# G-01: Daily Field Report

Project Name:	Nanuet UFSD - Senior High School (Phase III)	Date:	02-22-24
Location:	103 Church Street - Nanuet, NY	W.O.#:	11432.03

011 - RFI #11 CHANGE DETAIL TO WELDING

ANCHOR PLAN VIEW RTU-HS-4 & 5  
SCALE: 1/2"=1'-0"

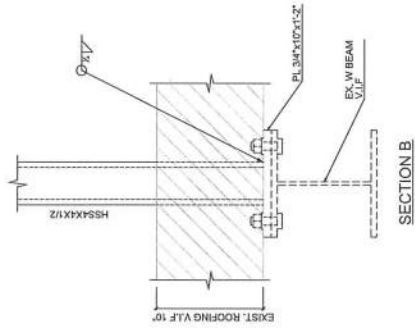
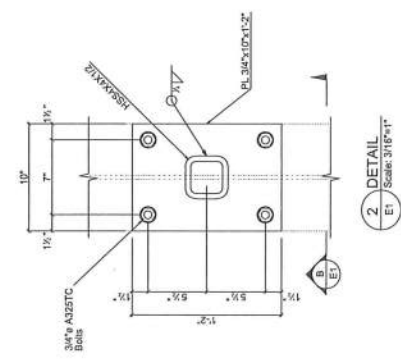
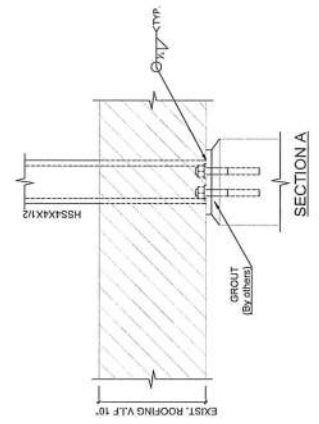
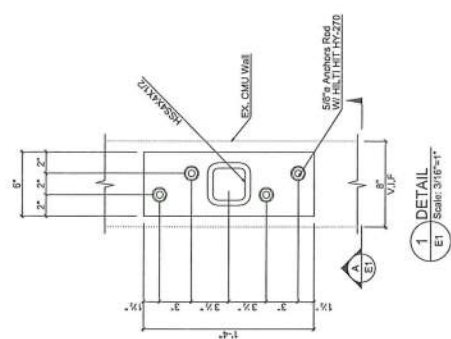
The other two (2) HSS post base plates were required to be installed per the original design [with four (4) 5/8" dia. threaded rod anchors installed with Hilti HIT HY-270 epoxy]. The adhesive anchoring was performed on prior date(s) at all but one (1) anchor location. See the attached highlighted E1 plan view sheet for the location where it was not done (due to an existing bar joist top chord interfering with the proposed location. The Engineer of Record responded after today's inspection and is requiring the location to be shifted approx. 2" to avoid the existing bar joist top chord. Given that all other adhesive anchor nuts were snug-tightened and the specified non-shrink grout was installed below each base plate, Tectonic can approve acceptance of this work via photograph on a future date (considered a punch-list item for now).

**[ (1) Threaded rod still requiring re-location per BOR directive ]**

They should drill another hole that will miss the bar joist. It looks like it has to shift towards the column about 2".

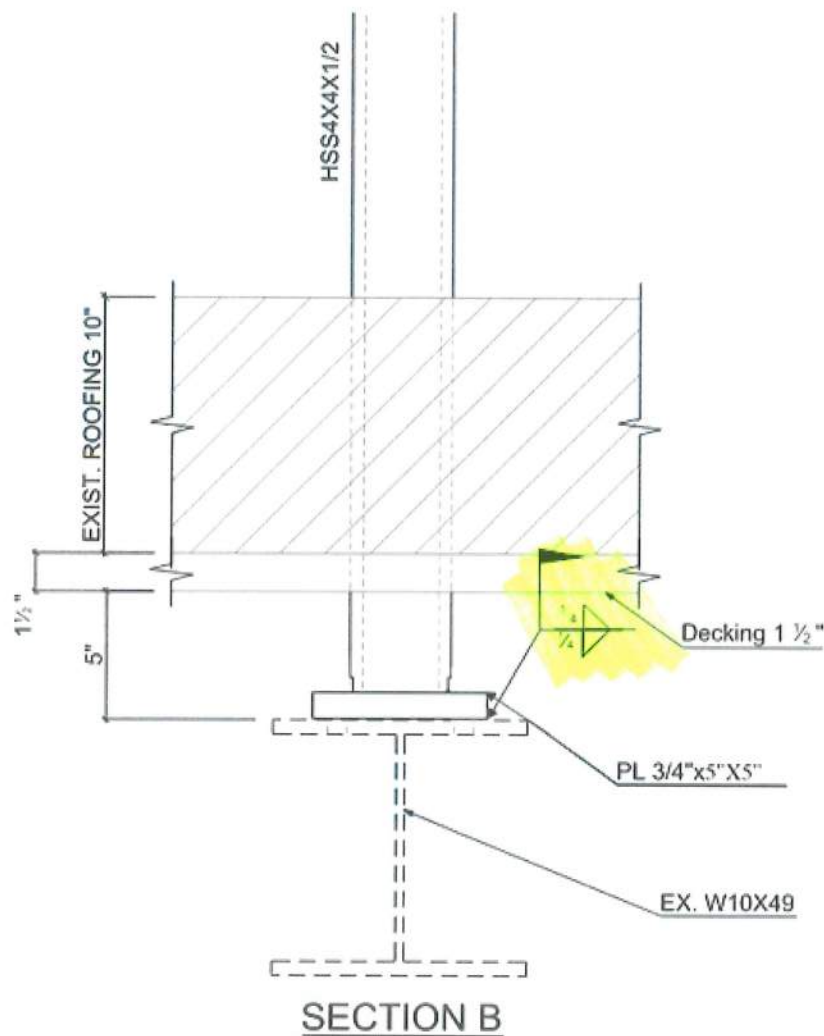
When I UNITED IRON was laying out the roof openings for the posts, they discovered on the far side of the beam the adjacent bay of joist is not where they were believed to be as per the Structural Contract Dwgs.

We propose to switch this to welding. The locations stay the same.

Please see below is the proposed weld detail.

Clapper Structural has Reviewed this RFI and find it acceptable to field weld the plate to the existing beam instead of bolting. All 4 sides of the plate need to be welded to the existing top flange of the existing beam

[ N/E item to be closed upon completion of new adhesive anchor installed ]

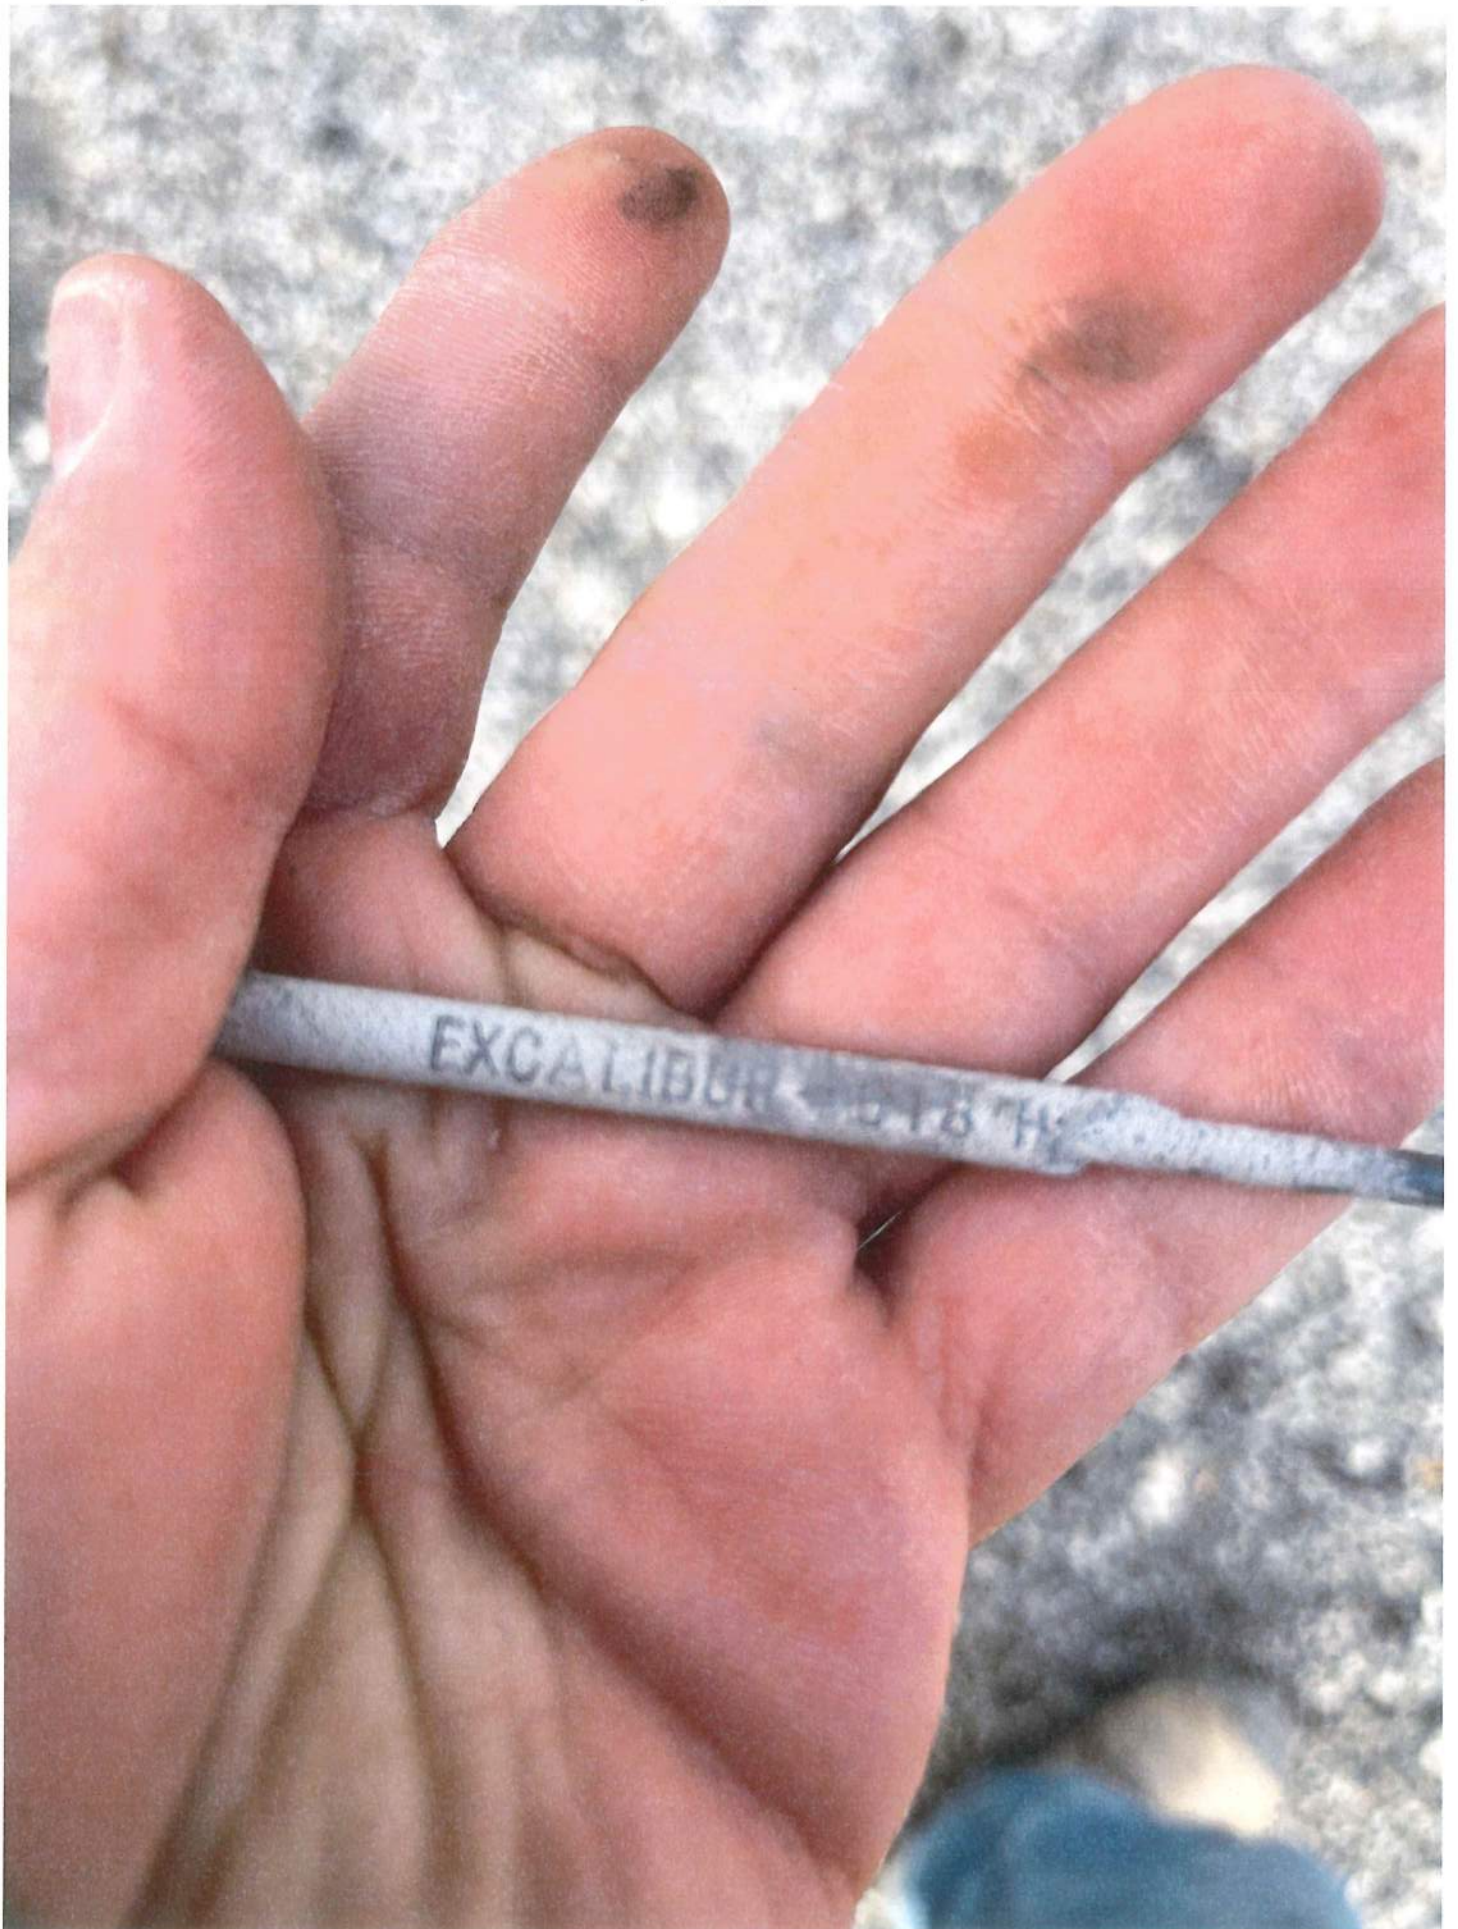
[ loc. of exist. bar joint top chord interference ]

[ original anchor loc. to be shifted ]
